Goulburn Mulwaree Council
Locked Bag 22
Goulburn NSW 2580

12 February 2026

**Subject: Merino Solar Farm (SSD 59155459)
Request for comments on the Environmental Impact Statement**

Figure 1: Figure 3-1 as presented within the Landscape Character & Visual Assessment report

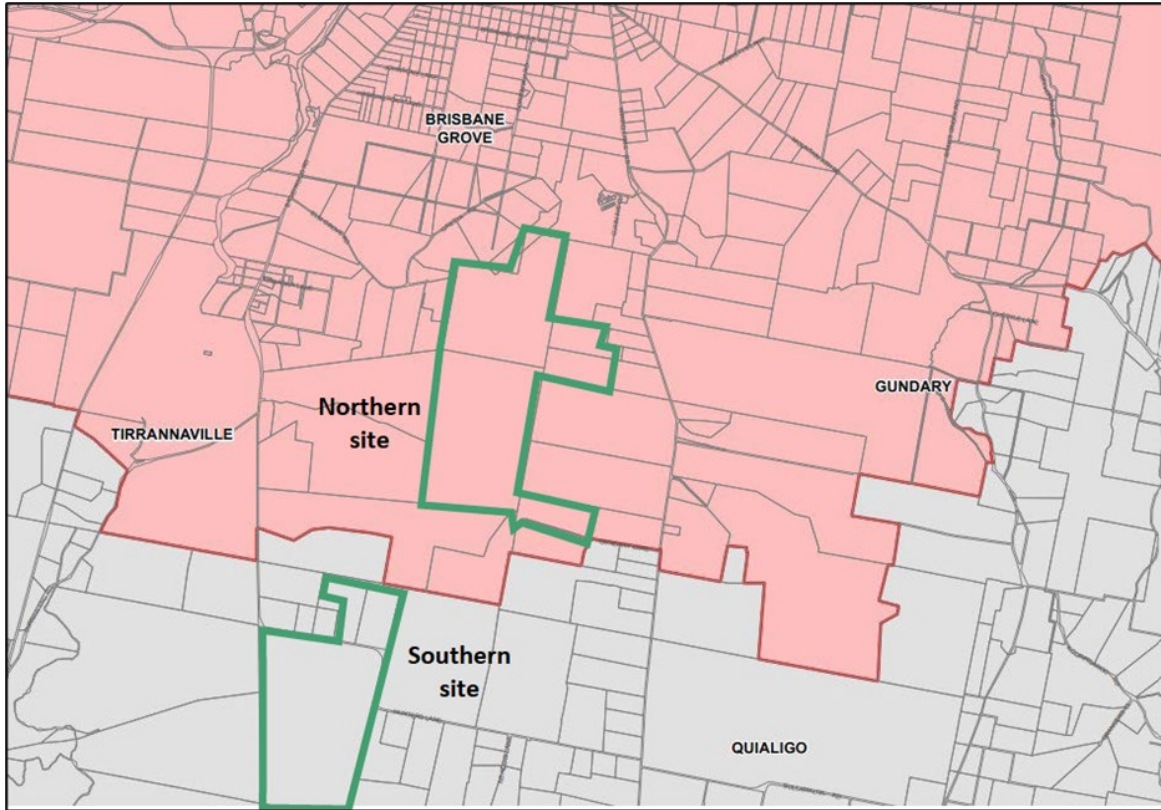
Contrary to some commentary relating to the SEPP within the community, the inclusion of the city of Goulburn as a *Regional City* does not automatically preclude the development of a solar or wind farm in the mapped area. Rather, the intention and practical application of the clause is to ensure that the proposed location of a solar or wind farm will not inhibit the capacity for growth or impact upon the scenic quality and landscape character of the area. In order to establish this, both the applicant and the consent authority must be able to clearly demonstrate how this clause has been met.

Section 4.2.2 of the Landscape Character & Visual Assessment provides an accurate assessment of the likely impact upon growth, insofar as limiting the physical footprint for growth and development of the city, which is minimal given the majority of Goulburn's anticipated residential growth will occur in the CBD and the north-western arc between Run-O-Waters and Middle Arm Road (as per Council's *Urban & Fringe Housing Strategy*). However, concerns are held for the likely significant and adverse impact that the proposal will have on the scenic quality and landscape character of the Gundry Plain.

The large-scale presence of solar arrays, characterised by large blocks of black and dark grey (as opposed to the greens and golds) both individually and cumulatively when also considering the proposed Gundry Solar Farm, will undoubtedly interfere with and adversely alter this landscape characteristic. It is therefore considered that clause 2.42(2)(b)(ii) cannot be discharged.

Figure 4 - Figure 4-3 from the Landscape & Visual Assessment report

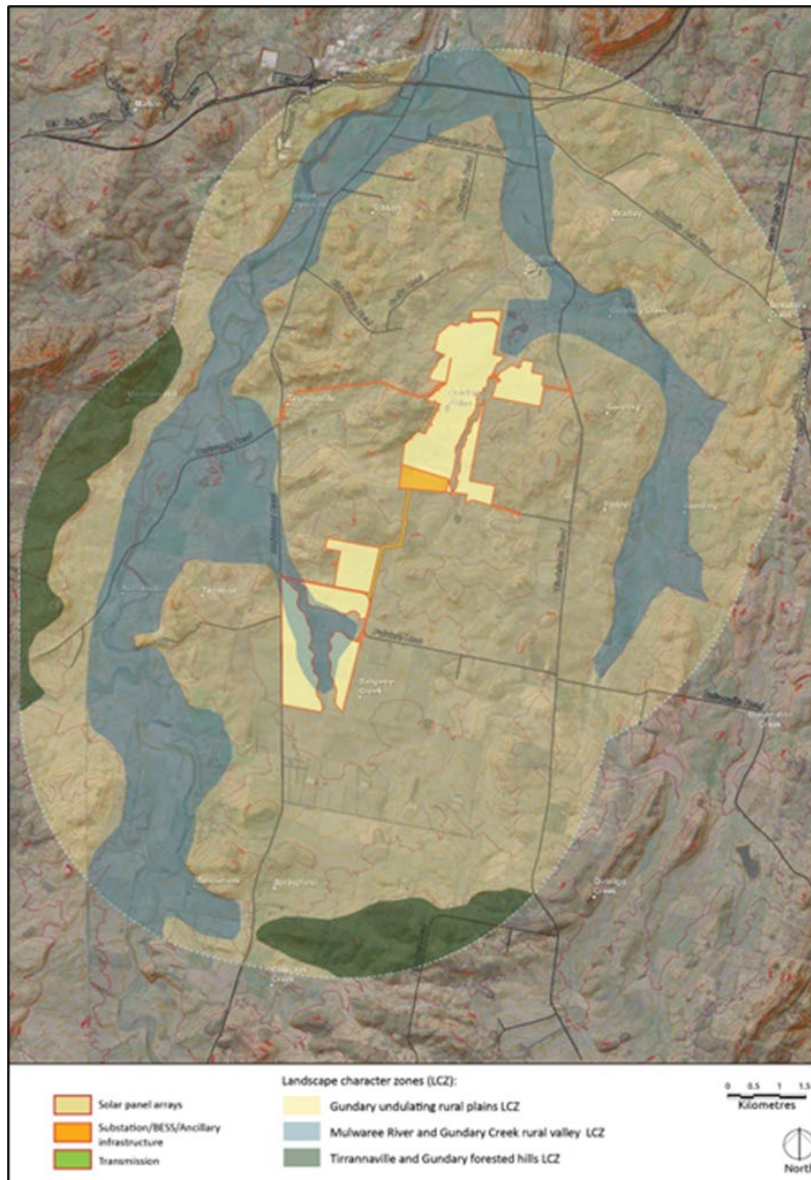
As can be seen from the above figure, most of the project area falls within the LCZ "Gundry undulating rural plains".

Figure 6 - SEPP assessment map showing proximity of Gundry and Merino Solar Farm sites

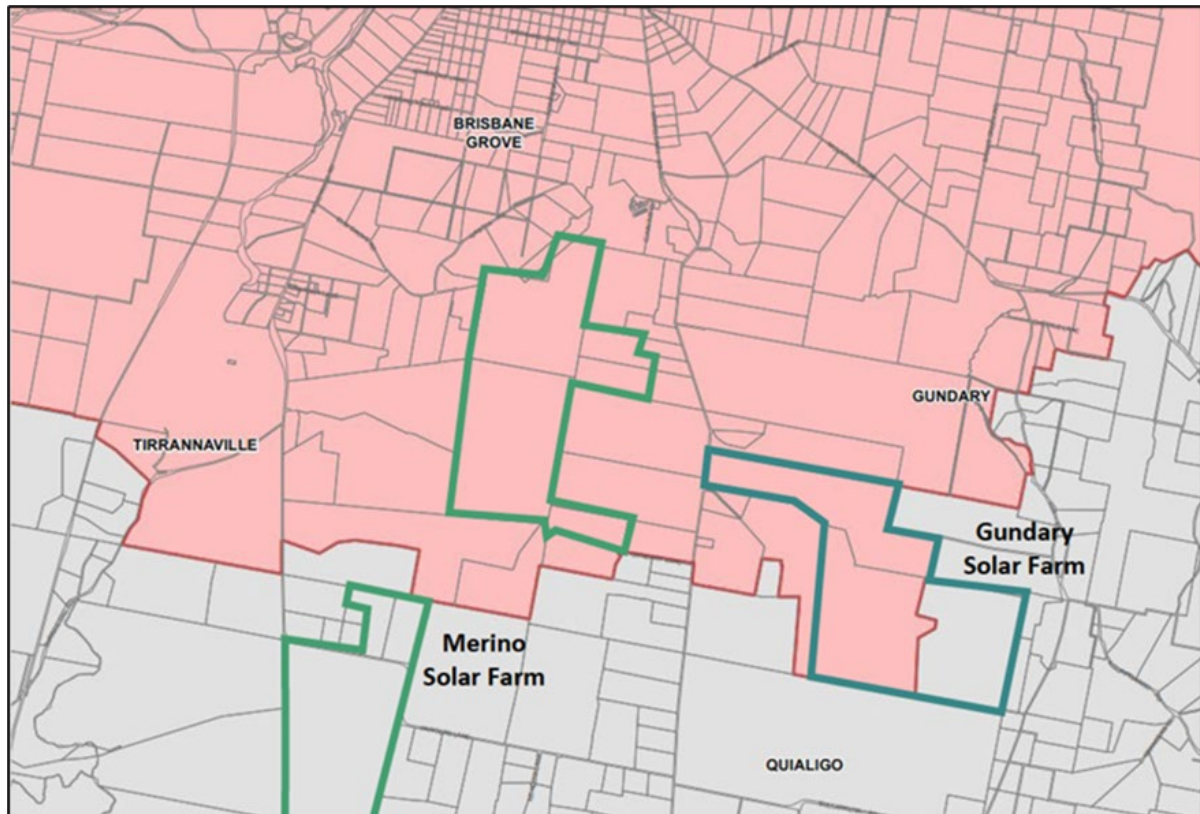
The SEPP assessment response and cumulative impact with Gundary Solar Farm concluded that there would be no impacts to the scenic quality of the city given the scale of the landscape. However, given the scale of both the proposed Gundary and Merino Solar Farms, this is a statement that both Council and the residents of the Gundary Plain typically disagree with.

This section of the report is relatively brief and does not include photo montages or more detailed assessments as provided for residences and public viewpoints. Further detail is warranted in this regard if the applicant is to sufficiently demonstrate compliance with Clause 2.42(2)(b)(ii) of the SEPP in relation to scenic quality and landscape character.

Figure 10: Extract from GMC flood model

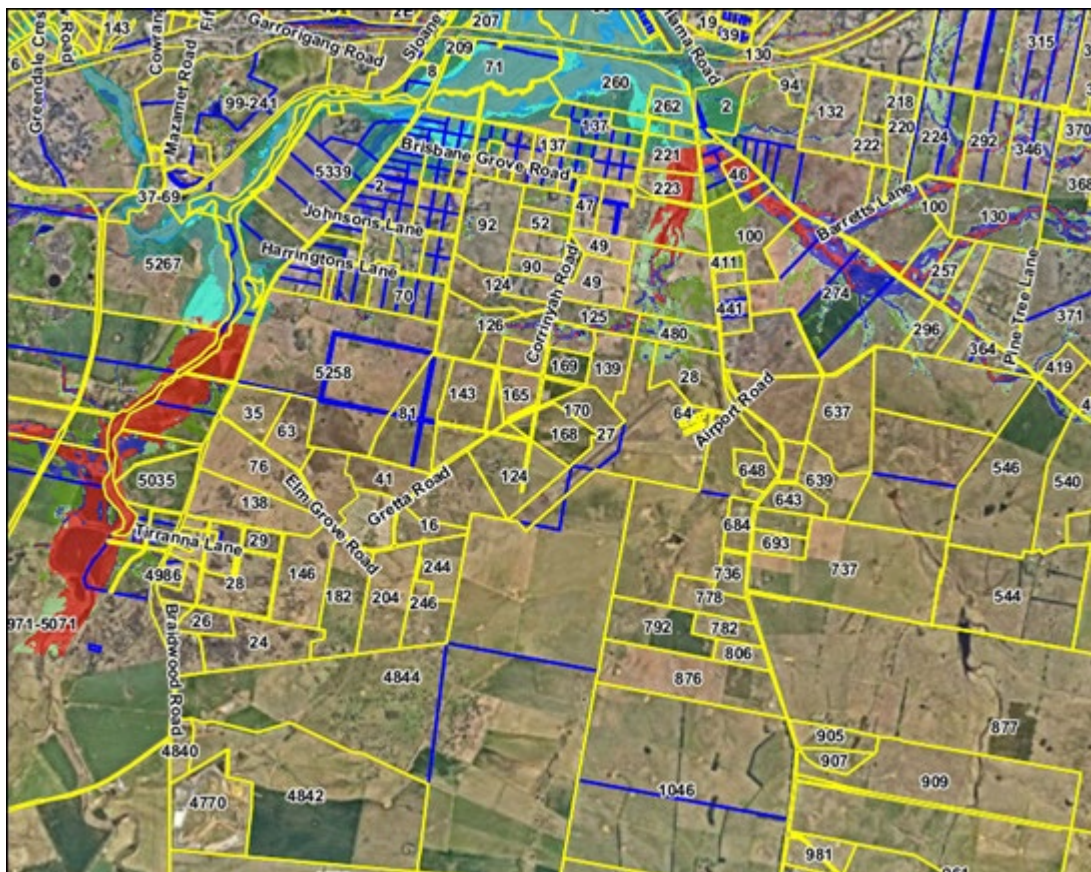
In relation to site access, Braidwood Road is cut at the bridge prior to the 1%AEP and Windellama Road around the Brisbane Grove intersection and near the airport more frequently again. The site is not considered a “sensitive use” in relation to flood evacuation and isolation, so flood issues would mainly relate in this instance to potential risk to the infrastructure itself or impacts post development on flood behaviour.

Figure 11: Post development flood modelling

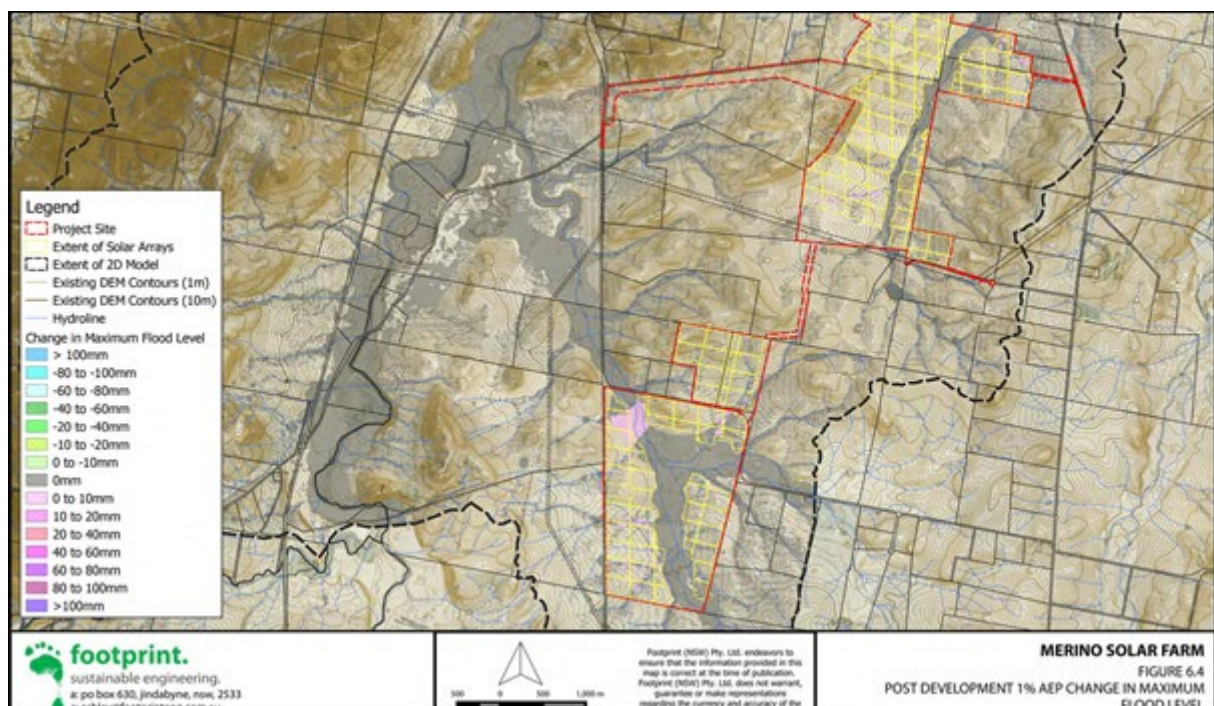
Post development flood mapping indicates little post development change to predevelopment levels. A small area shown in pink (Figure 11) demonstrates a 0 – 10mm increase which is negligible and contained within the subject site. In other words, there appears to be no downstream or off-site impact.

It is worth noting that the post development velocities are generally reduced by 0.25 to 0.25m/s. Based on the above, predevelopment and post development flooding is substantially the same except for the overall reduction in velocity. A reduction in velocity is a positive result in relation to sediment and erosion impacts.

Figure 12: Figure 3-2 from the Biodiversity Report

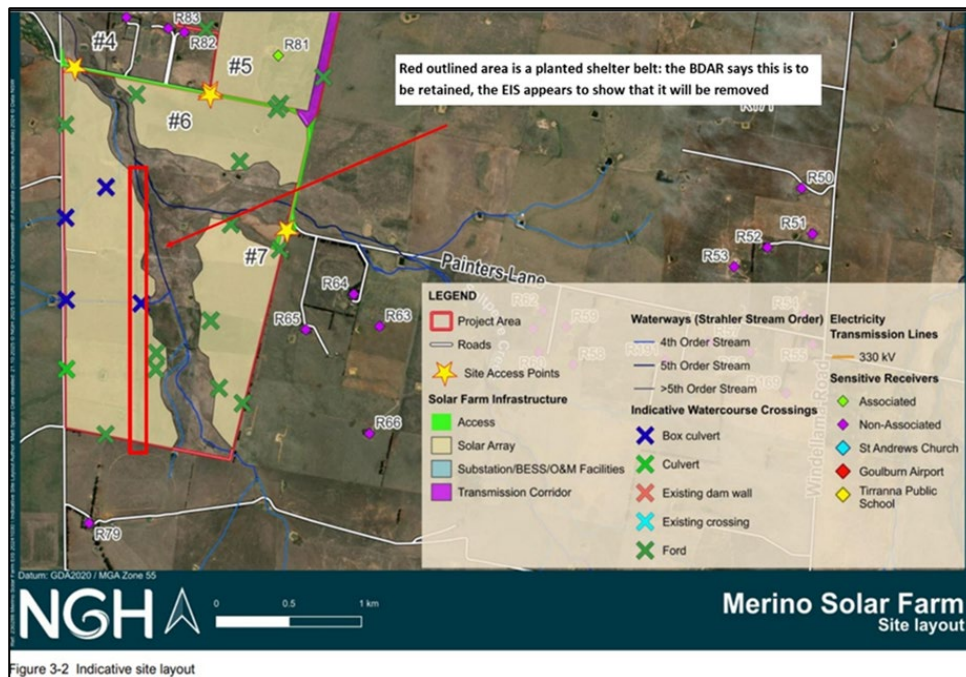
References in the EIS in relation to the retention of trees within the Development Footprint are confusing and contradictory. Figure 3.1 Development Footprint (page 37) and Figure 3.2 Indicative Site Layout (page 38 - extract below) both suggest that the major planted shelter belt running north to south in the southern site is to be removed.

However, on page 142 of the EIS (Vegetation Clearing):

*"The project would result in direct impacts on 64ha of native vegetation. The majority of this vegetation is poor to low condition and has low biodiversity value due to historically and current agricultural pressures with limited connectivity to other native patches. The clearing would involve the removal of nonthreatened native plants. **No trees would be removed.**"*
